AGENDA
VILLAGE BOARD MEETING
Tuesday, January 11, 2022 at 7:30 p.m.
Jackson Municipal Complex
N168 W19851 Main Street
Jackson, WI 53037

RE: Amended Village Board Submittal for:
Morning Star Ev. Lutheran Church and School
Elementary School expansion and New Early Childhood Center Facility
N171W20131 Highland Road
Jackson, WI 53037

Plan Commission December Meeting – January 6, 2022

This letter is in response to emailed comments received on December 29, 2021 regarding the review of the Conditional Use Amendment submittal for the proposed Morning Star Early Childhood addition to be located at N171 W20131 Highland Road.

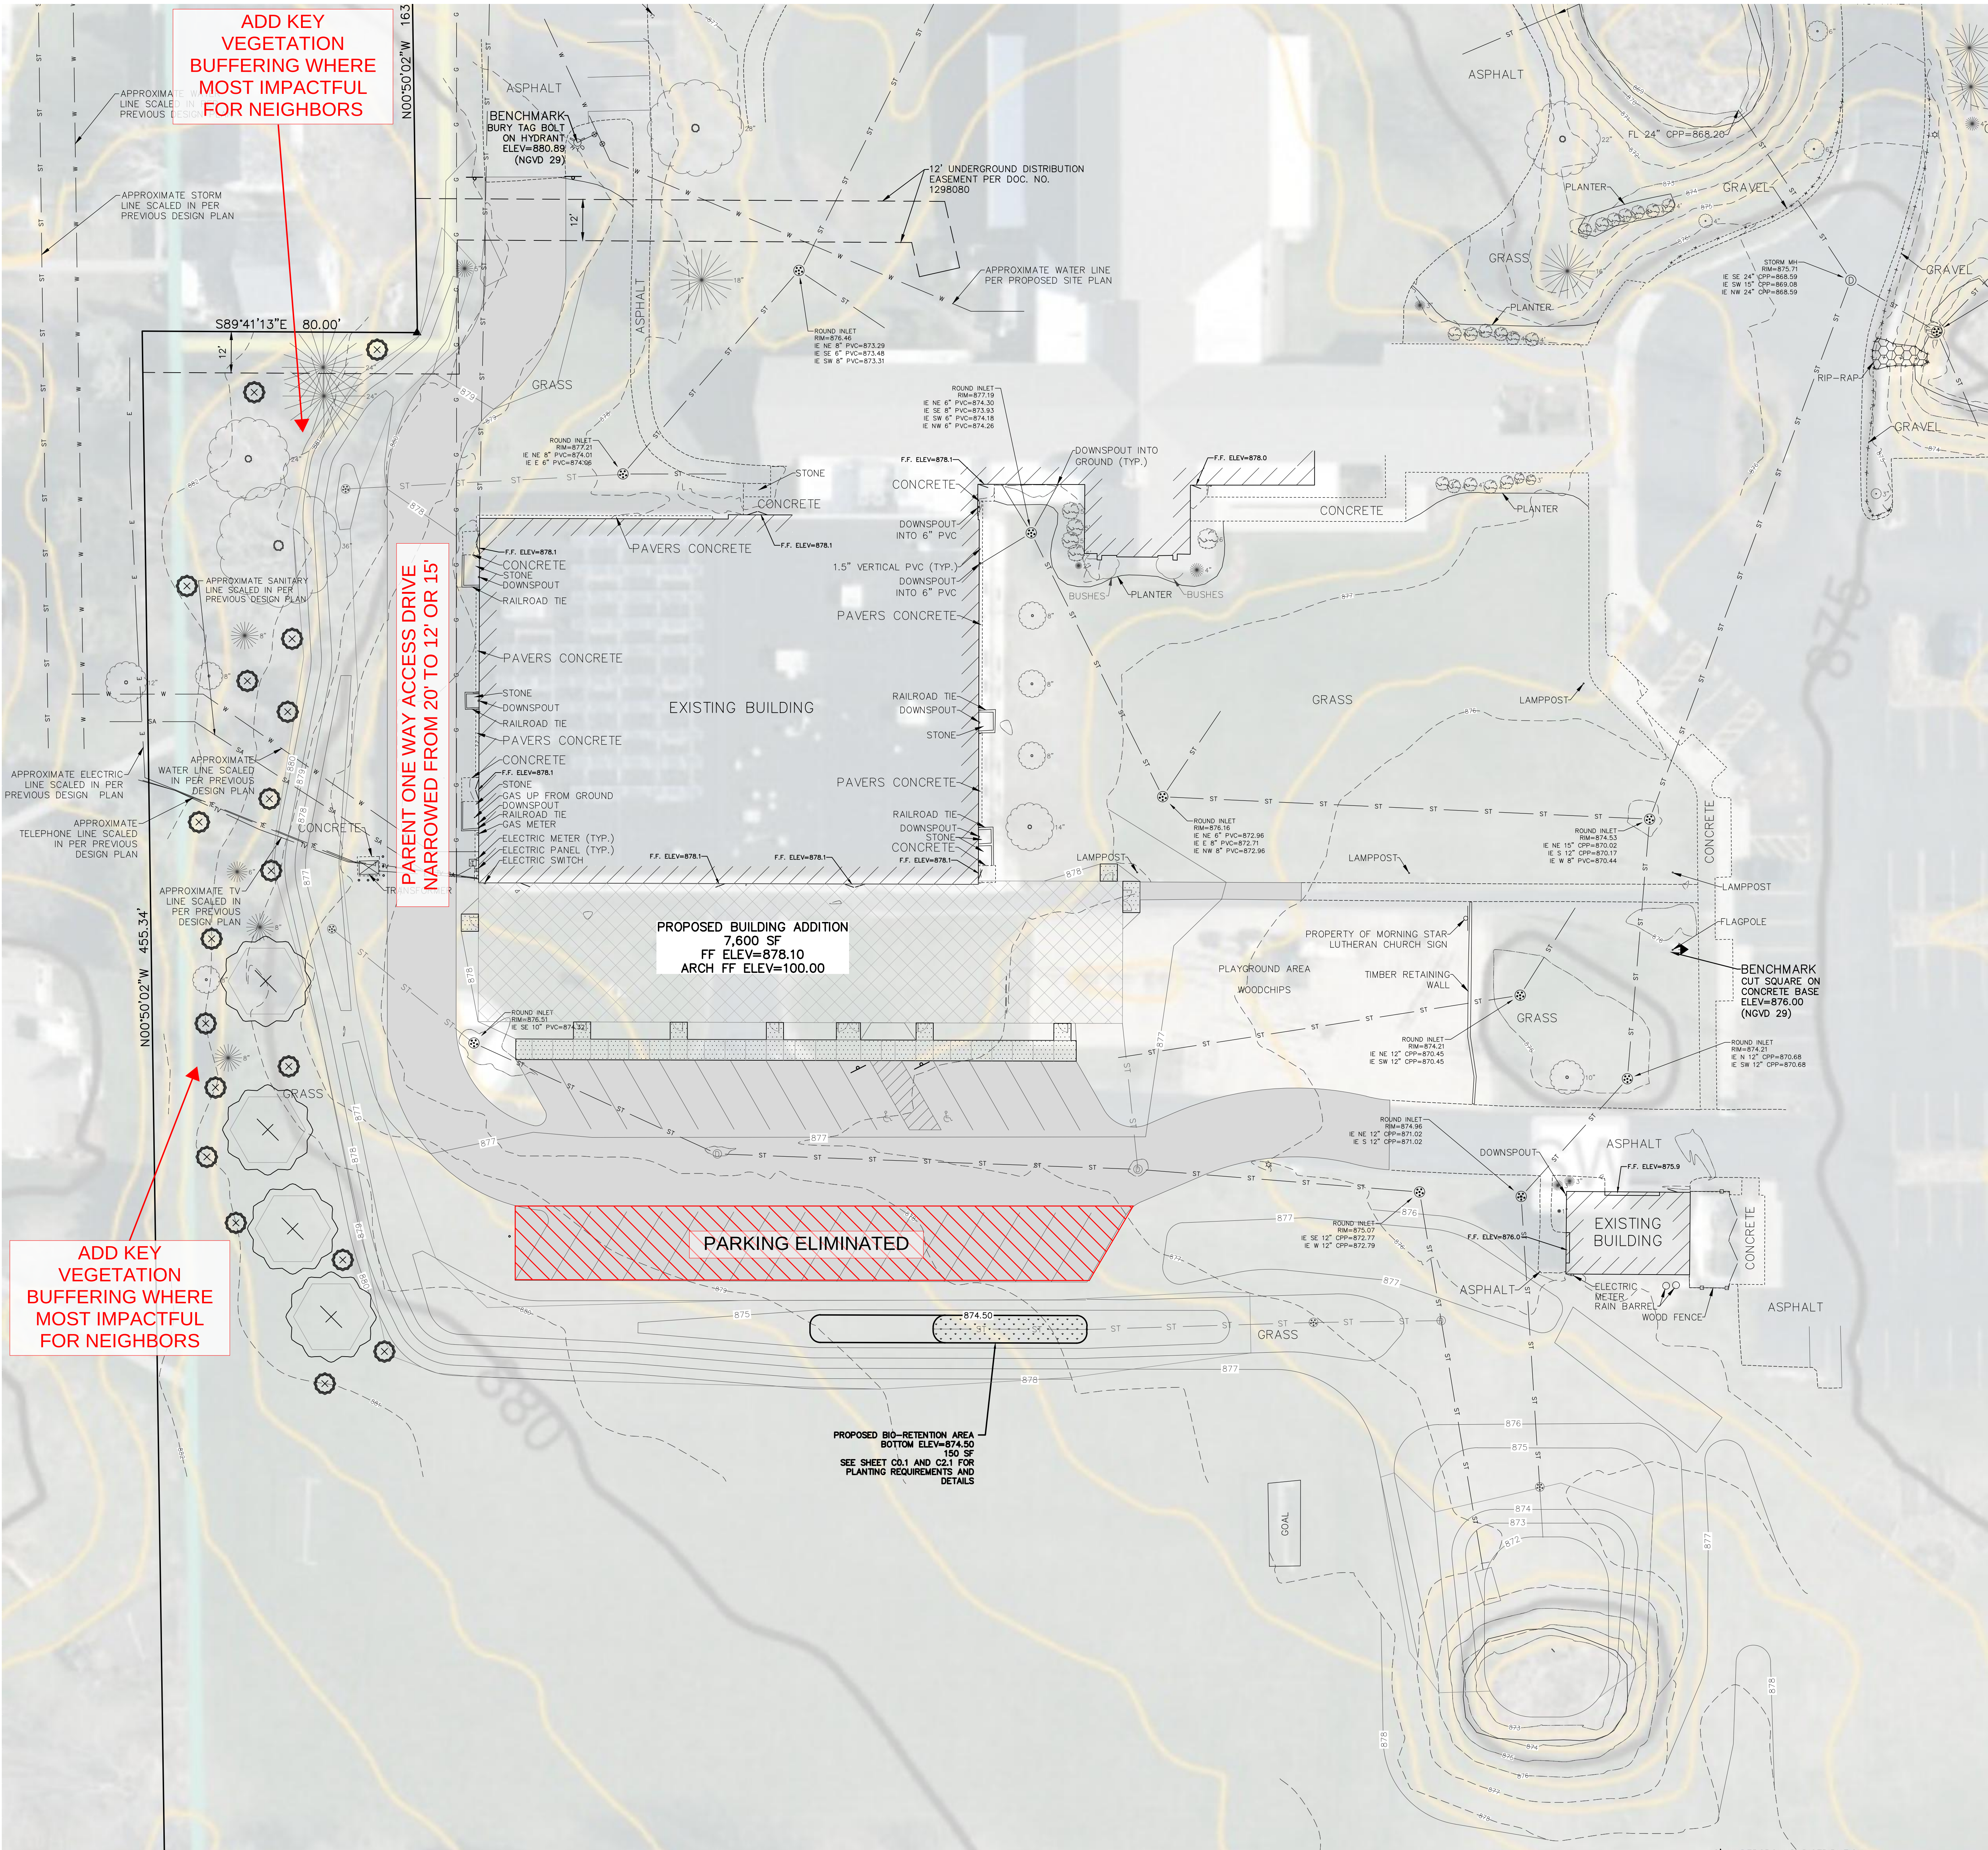
2. West access drive: The west access drive connects an existing fire lane to a small parking lot area on the northwest portion of the property. This one-way drive allows childcare parents front entrance access and creates a separate and limited traffic flow (morning drop off and afternoon pick up) for increased vehicle and child safety at those times. Annually our parents are provided a welcome packet for the school which instructs the traffic patterns required for drop off / pick up. After consulting with the Fire Chief, this west drive is not needed for emergency vehicle so the drive can be narrowed for private vehicle use only. We are currently assessing the which direction of the one way traffic best balances on site traffic safety and will provide a final determination at the Board meeting. Currently the traffic flows from the main parking lot and exits on the northwest corner of the site.

3. Voluntary buffering from adjacent neighboring properties: The west side of our property is not an active pedestrian side of our campus. With the addition of limited vehicular drop off one way traffic we will be adding selective vegetation buffering to maintain a natural setting where it will best benefit our neighbors.

4. Site Lighting at Drop off parking and west access drive: With the narrowing of the west access drive and the drop off parking area, we will utilize the existing cut off wall mounted light fixtures on the west gymnasium wall and provide new similar fixtures on the south wall addition. By doing so, we will maintain existing low lighting levels directly adjacent to neighboring properties.

ARCHITECTURAL
SITE PLAN
AS100

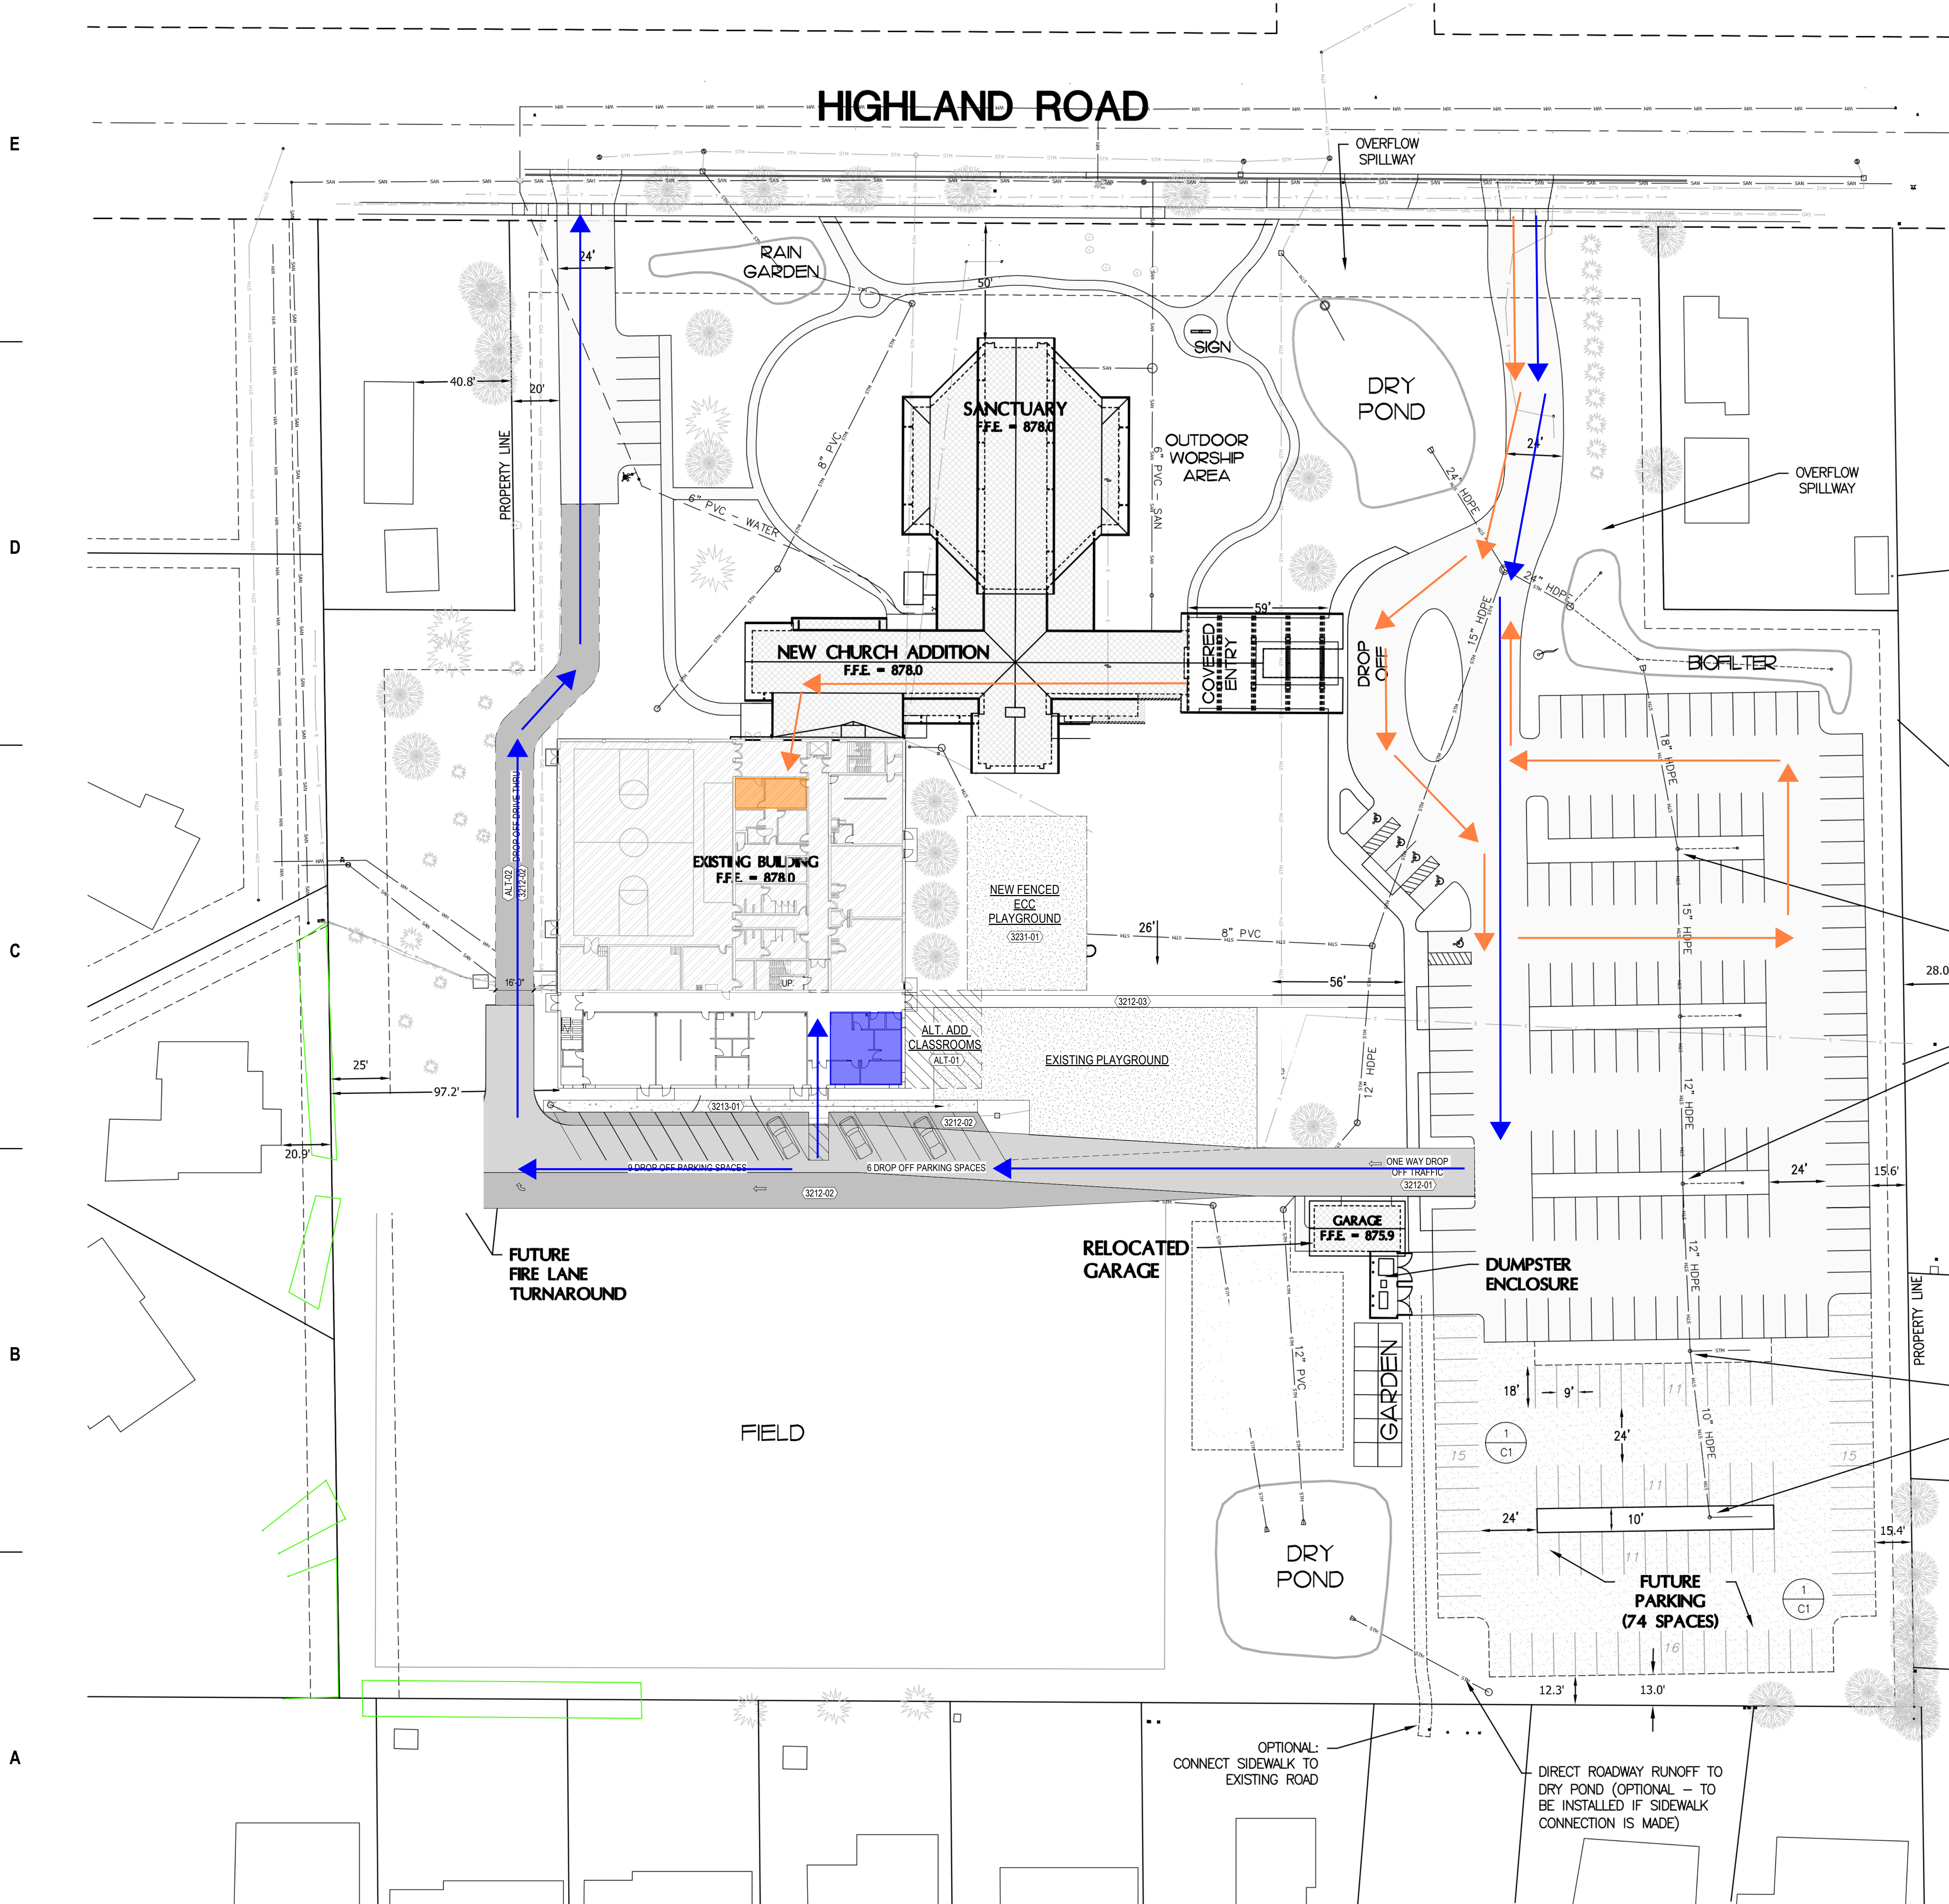
- Proposal includes a two-story, 15,110 sq. ft. addition to the existing structure to provide additional area for early childhood learning as well as a reconfiguration of certain areas of the existing parking lot and creation of a new driveway along the west side of the property.

- Building plans do not disclose full construction details or proposed occupant loads so it is not possible to determine how the designer intends to meet the exception for not sprinklering the addition given the fact that the addition area exceeds the exceptions in both IBC 903.2.1.3 and 903.2.3.

- Fire sprinkler system may be needed in new addition as square footage of addition is over 12,000 square feet.
- State approved plans will be required.
- Fire Hydrant needed on south side of building.

- Proposal includes a two-story, 15,110 sq. ft. addition to the existing structure to provide additional area for early childhood learning as well as a reconfiguration of certain areas of the existing parking lot and creation of a new driveway along the west side of the property.
Excel Response: Correct.
